# **DEVELOPMENT APPLICATION**

## **RESPONSE TO INFORMATION REQUEST**

### **Mount Emerald Wind Farm**

April 2014

Figure 2: Wind Speed at 70m above ground surface

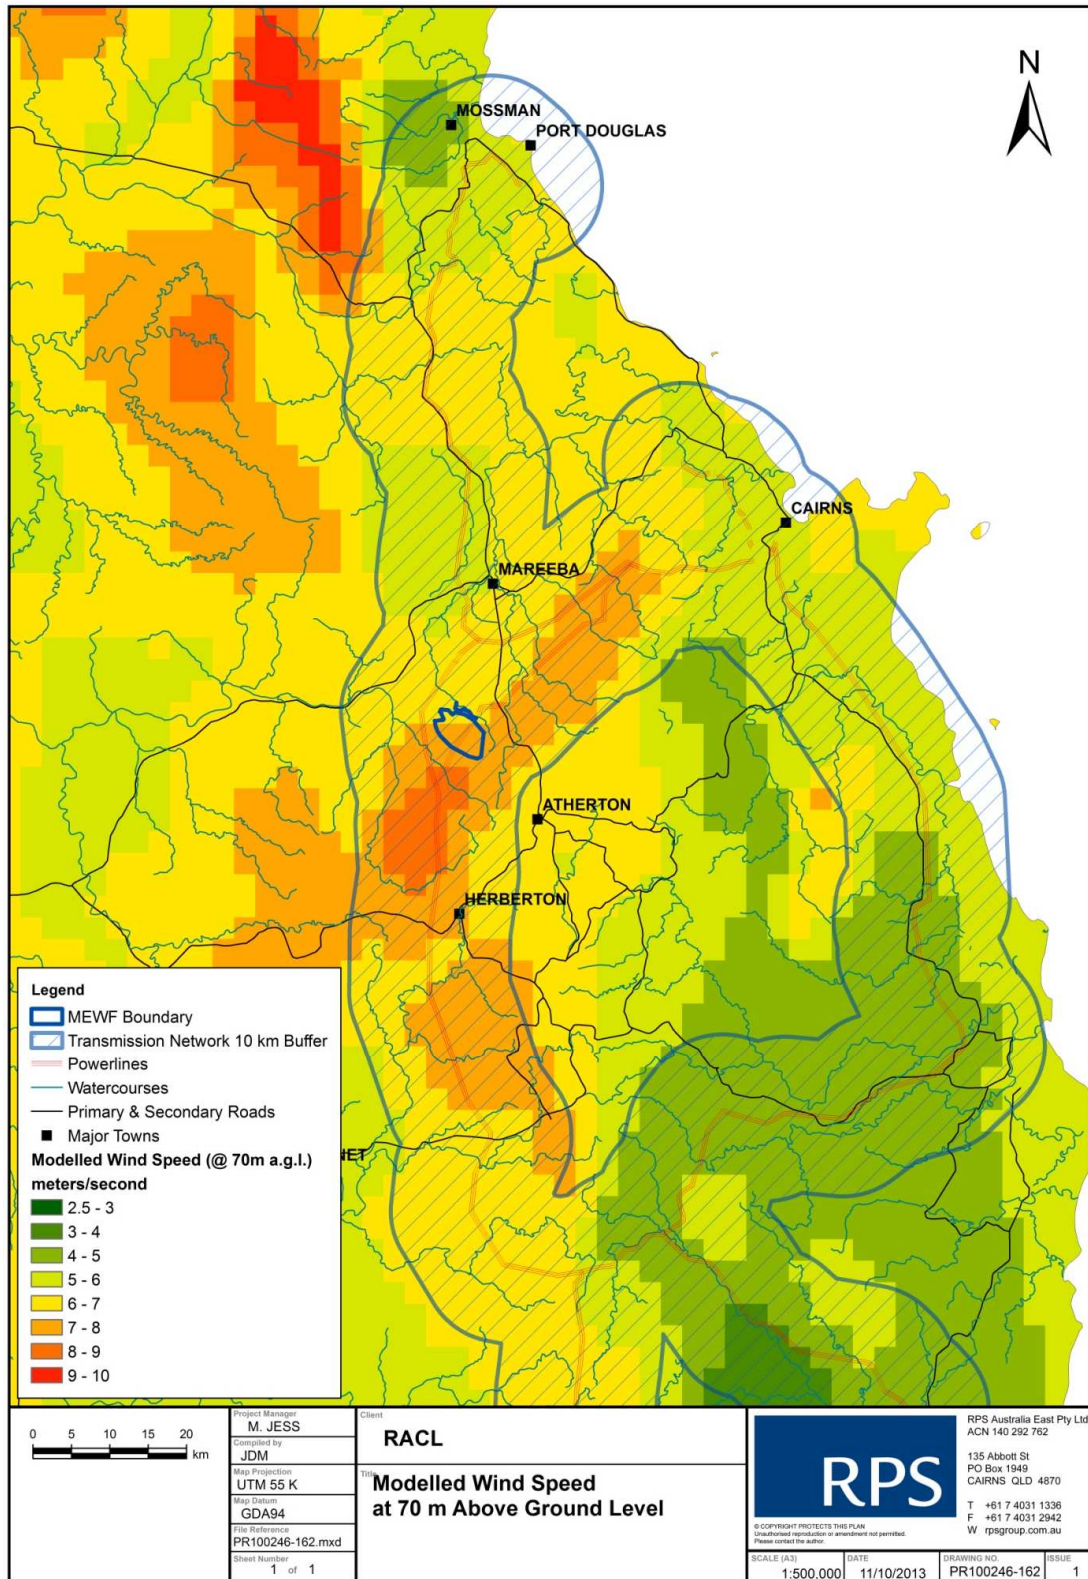
*Detail any alternative sites considered for the development, the characteristics of those sites, and why they were not chosen.*

Further investigation was conducted into other locations within the region with particular attention to the southwest of the subject land.

**Figure 3: Background Noise Level v Wind Speed (at 10m AGL) and Linear Fit for R5**

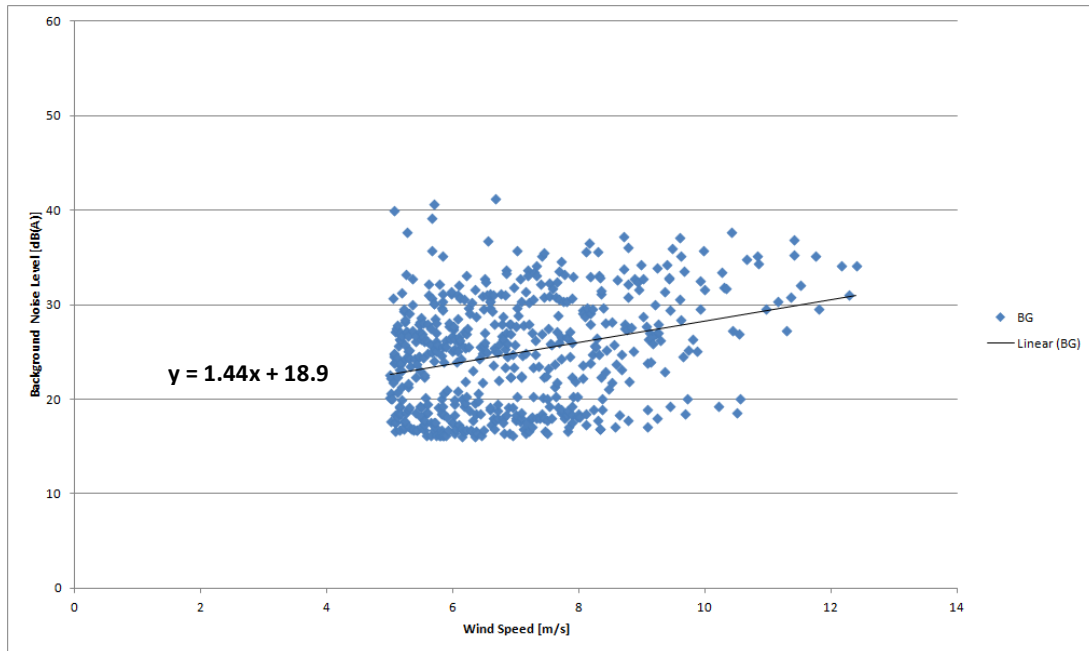
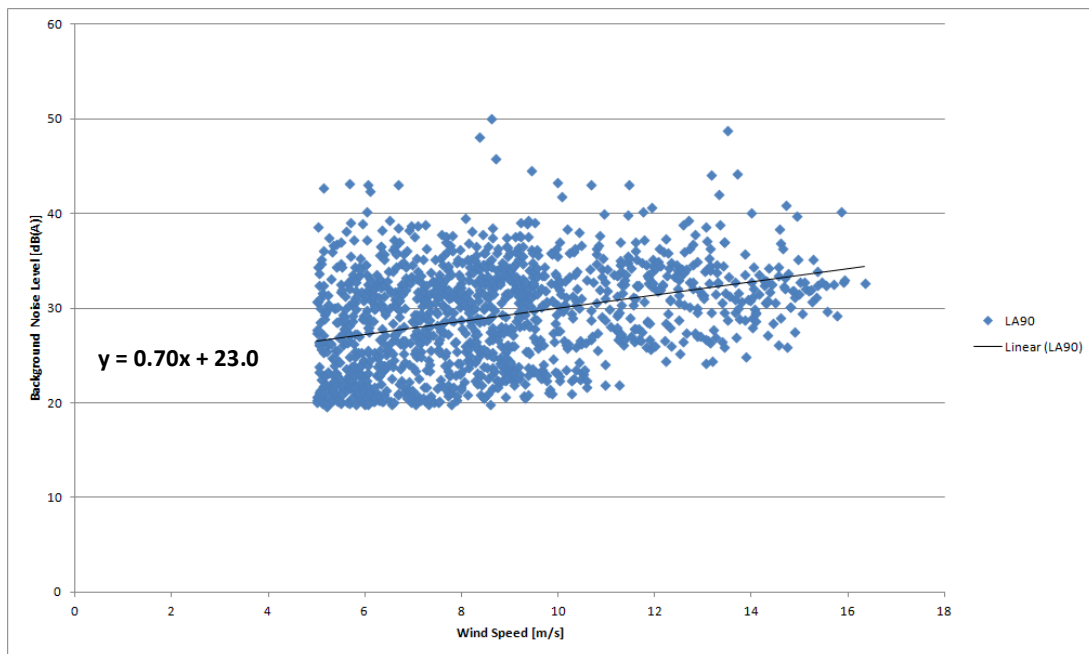
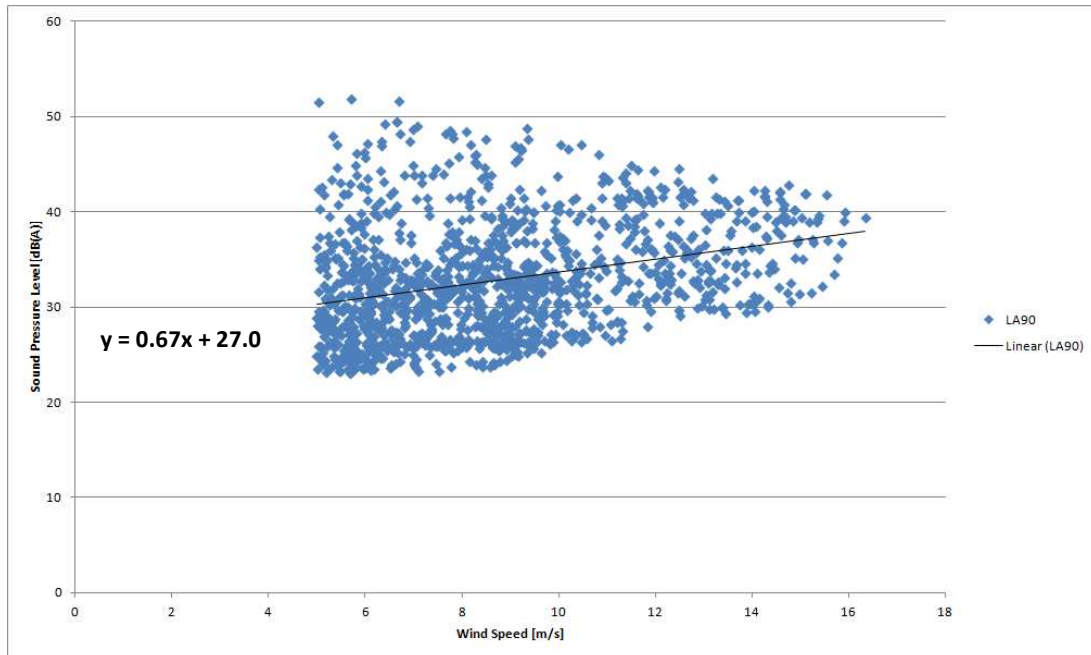
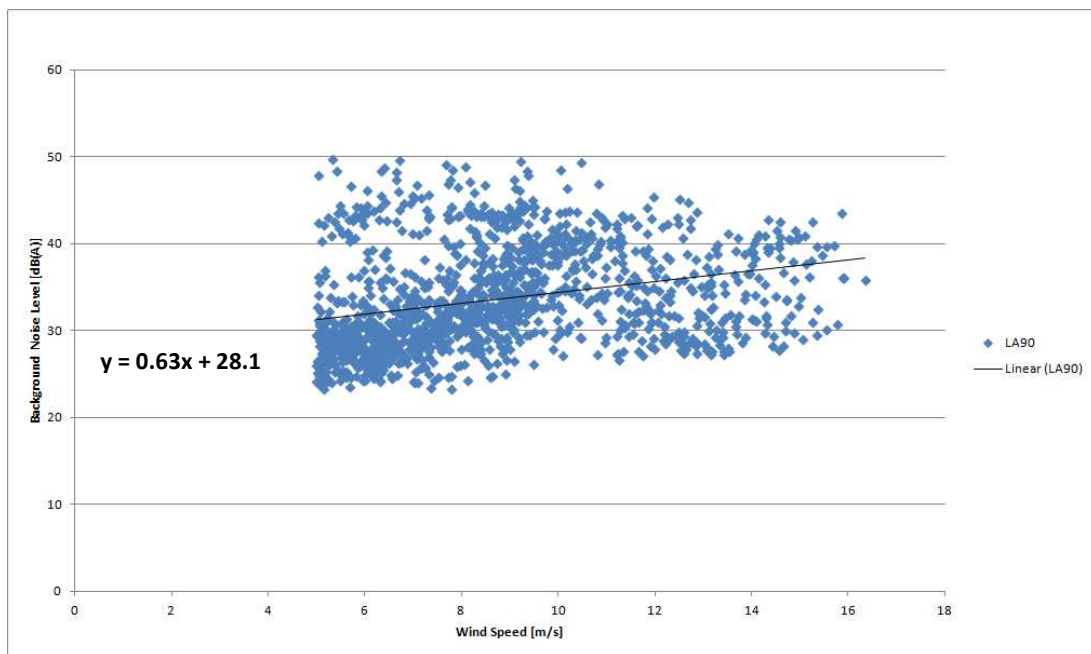
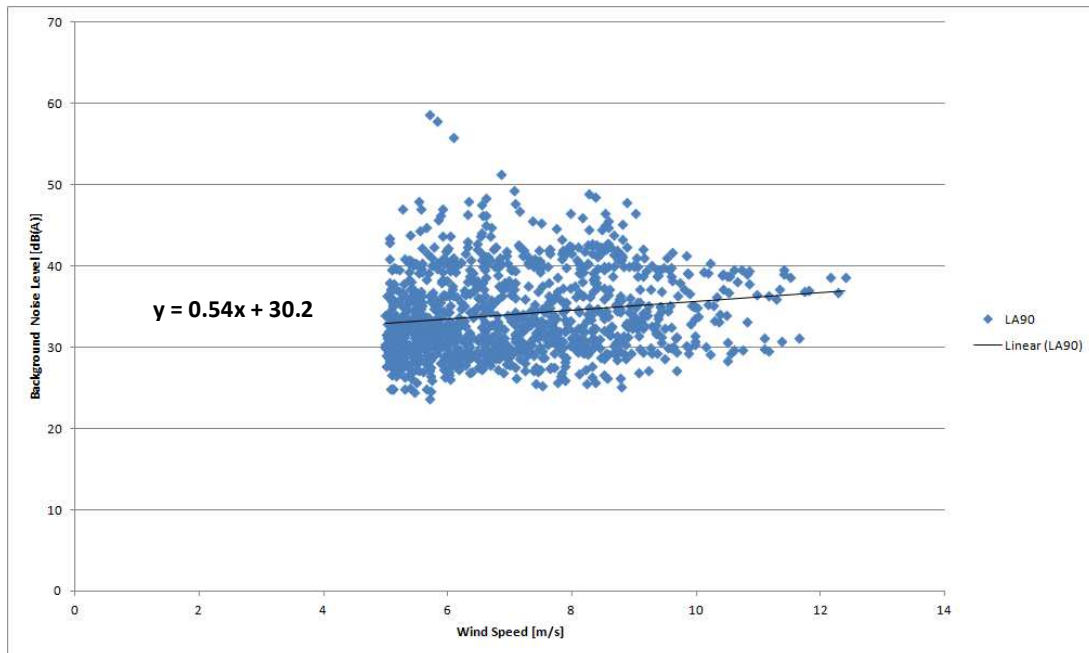
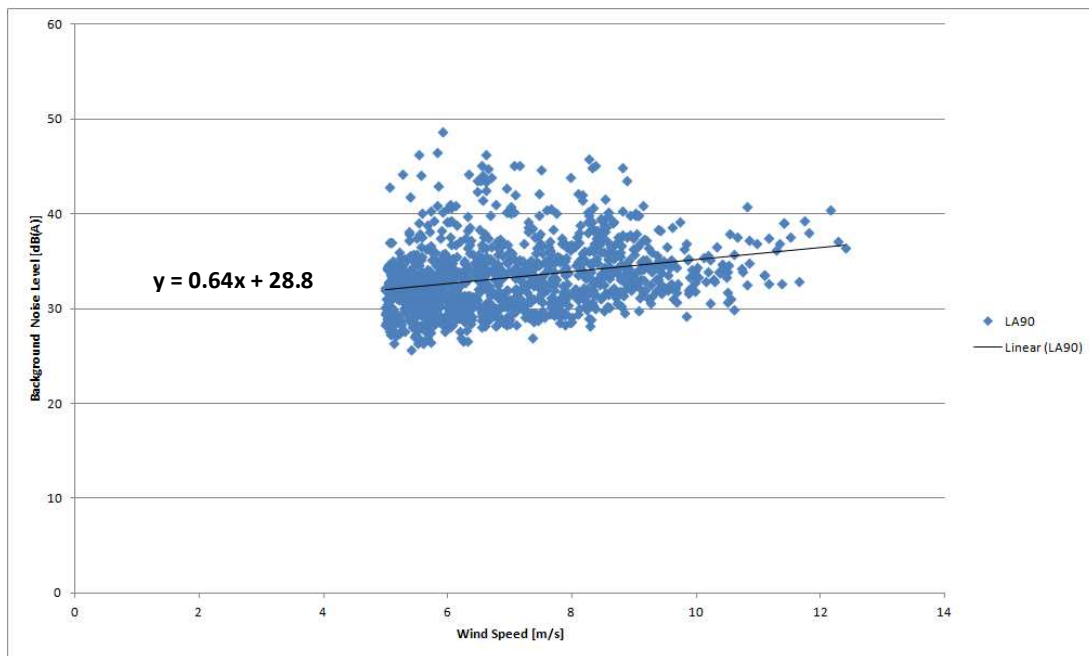
*Show the calculated regression analysis lines on the Background Noise Level v Wind Speed graphs for the six receptors.*

The calculated Background noise level v the wind speed graphs along with the calculated regression lines are contained in Figure 3 to Figure Y. It should be noted for Receptor 5 (Figure 3) the calculation of the best fit is based on a reduced data set. An obvious local noise source making a continuous noise at approximately 50 dB(A) and 57 dB(A) (Refer to Figure 3 from the noise report) was excluded from the background analysis.

**Figure 9: Background Noise Level v Wind Speed (at 10m AGL) and Linear Fit for R6**

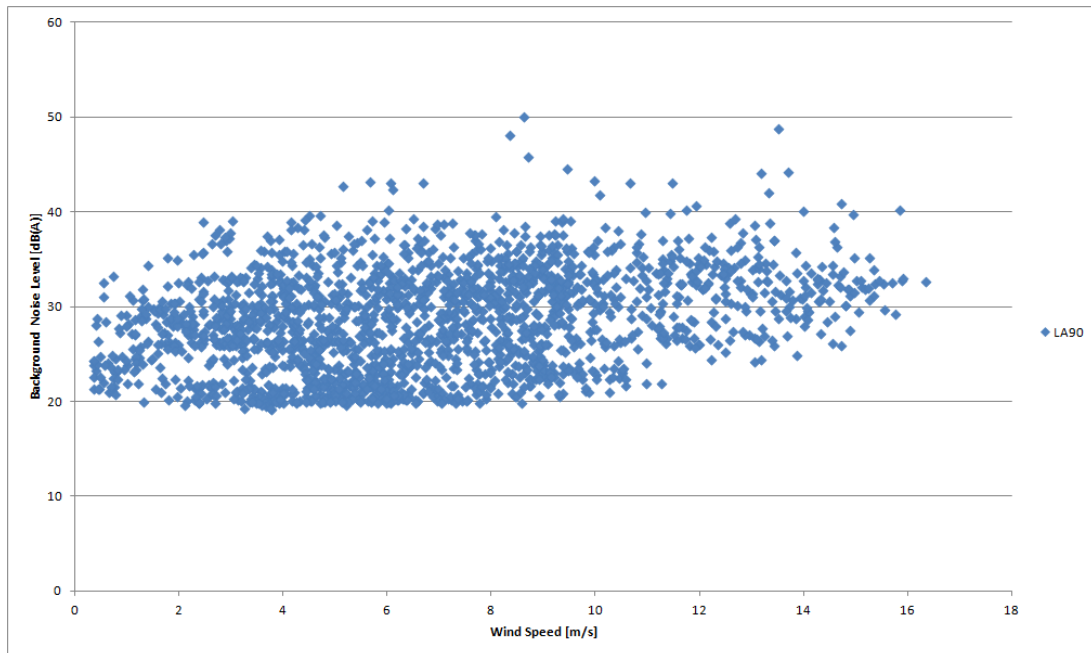
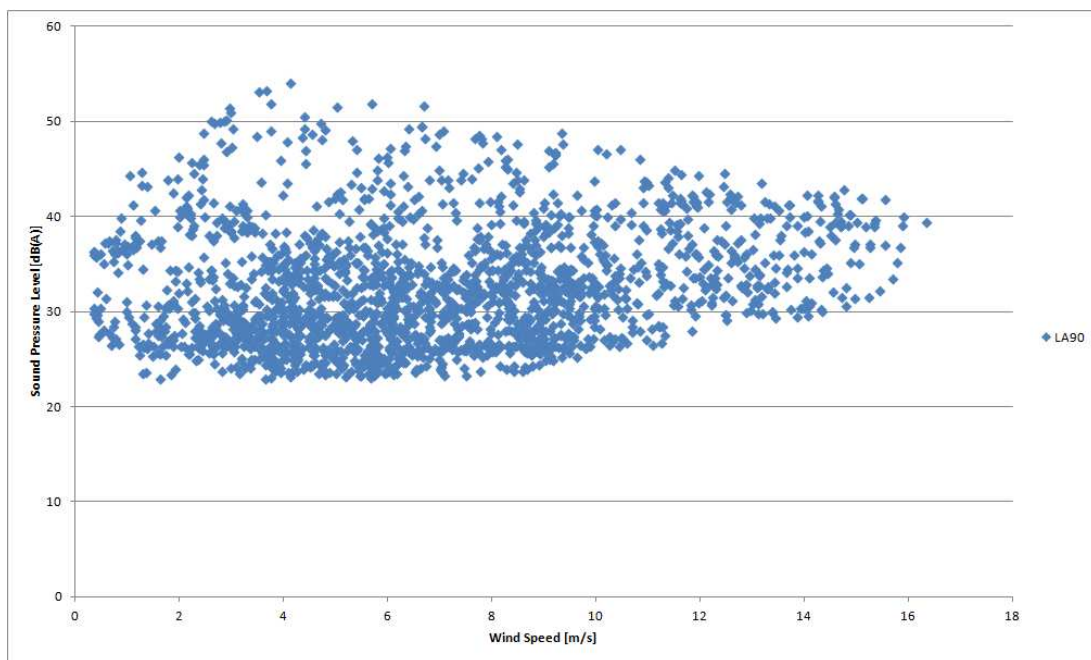
*The Background Noise Level v Wind Speed graphs for R06 and R16 are identical. Please rectify?*

**Figure 10: Background Noise Level v Wind Speed (at 10m AGL) and Linear Fit for R16**

**Figure 17 – Noise Zone – 40dBA Contour (Max. Noise) and Neighbouring Properties**

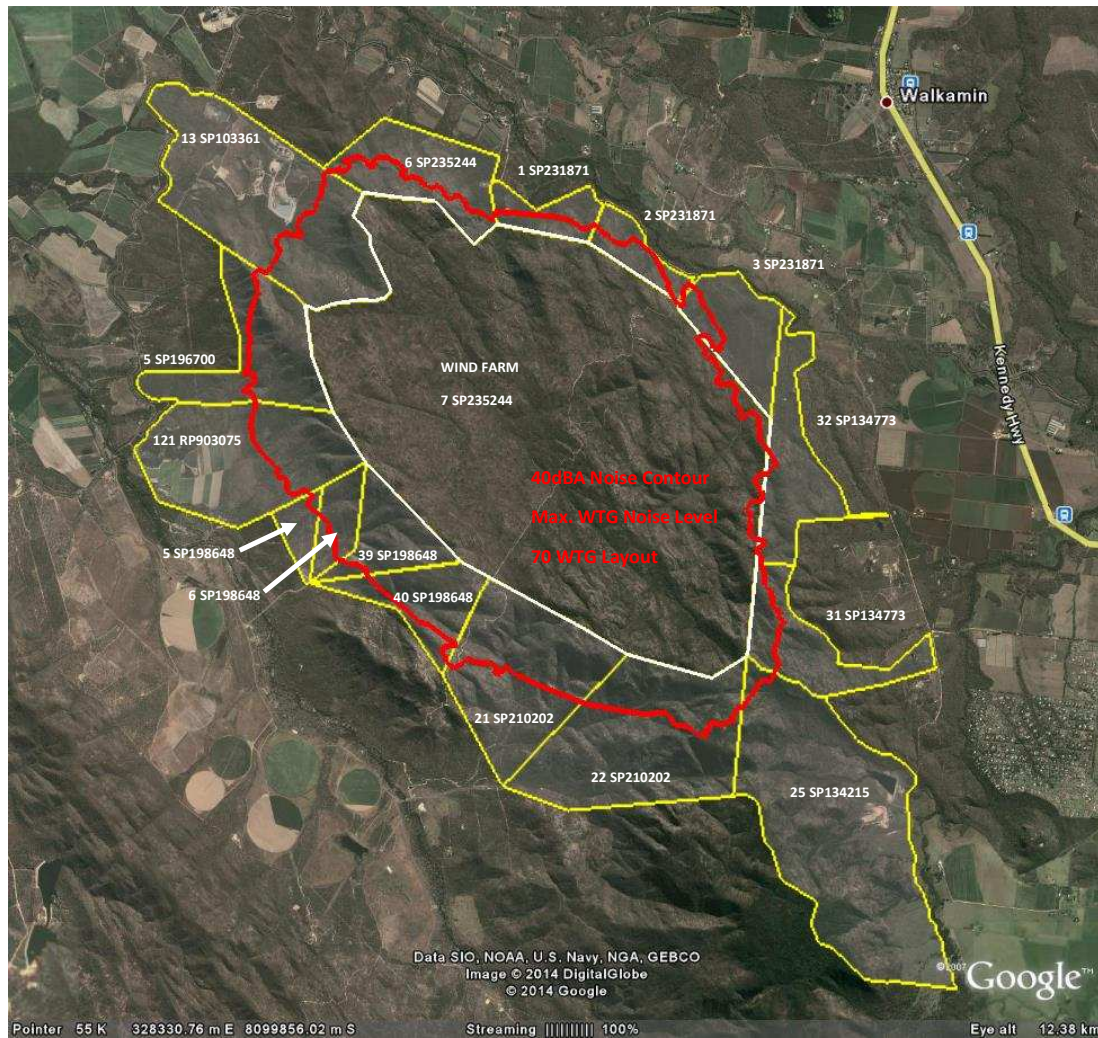
*AS4959-2010 defines a receiver as including the location of potential future noise sensitive development such as an occupied dwelling permitted under the planning scheme. The draft National Wind Farm Development Guidelines also identify areas where permitted noise sensitive development may occur within the life of the wind farm as a noise-sensitive receiver. There are a number of vacant rural lifestyle lots external to the site that could be potentially impacted by turbine noise. In addition, both Lotus Glen Prison and the Springmount accommodation camp are capable of housing large numbers of people.*

Figure 17 shows the 40dBA wind farm noise contour (under maximum wind turbine noise conditions) in relation to the neighbouring properties to the wind farm land.

**Figure 25 – Maintenance and Storage Facility – Example**

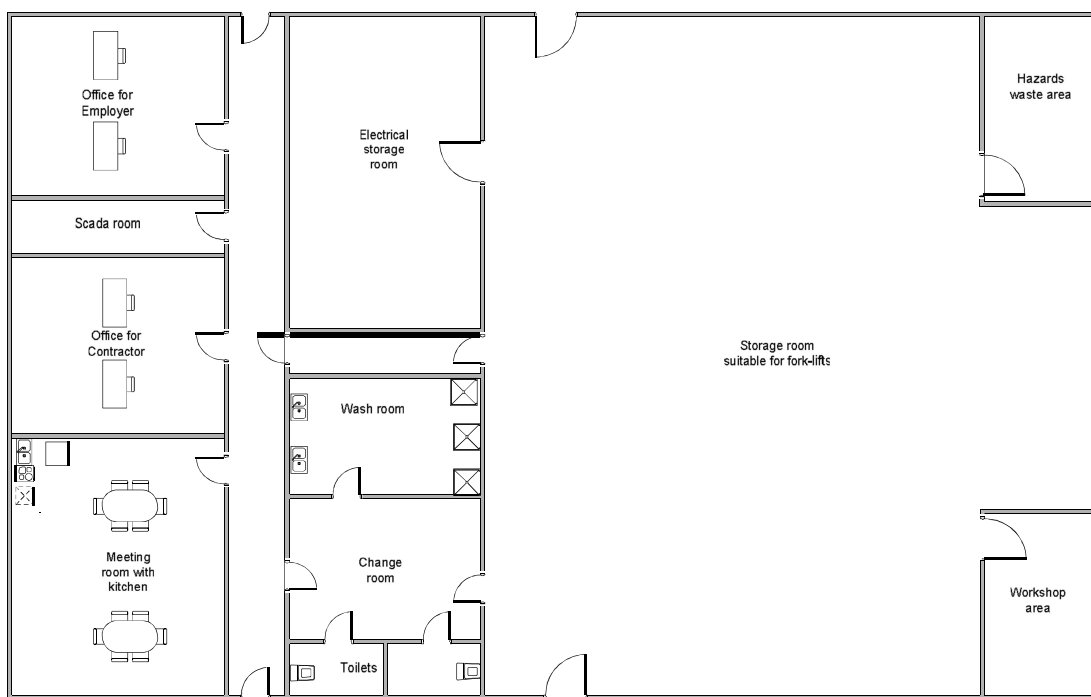
*The p 17 references to the maintenance depot are noted. Please provide further information including a location, indicative layout, dimensions and area, indicative building numbers and sizes, access information, and any proposed fencing.*

An operations and maintenance building will be constructed adjacent to the substation compound. This building will house the wind farm operational infrastructure, including monitoring and communications equipment. Maintenance facilities would include a store, work area and staff amenities, supported with rainwater tanks and a septic system. Car parking for operations and maintenance staff will also be provided adjacent to the substation compound.

The final number and design of buildings is not known at this time however buildings will be subject to approval under council process. Information on the layout of the building has been provided by the relevant wind turbine manufacturers with the largest configuration shown below with an overall area of 460m<sup>2</sup> (approx. 27m x 17m).
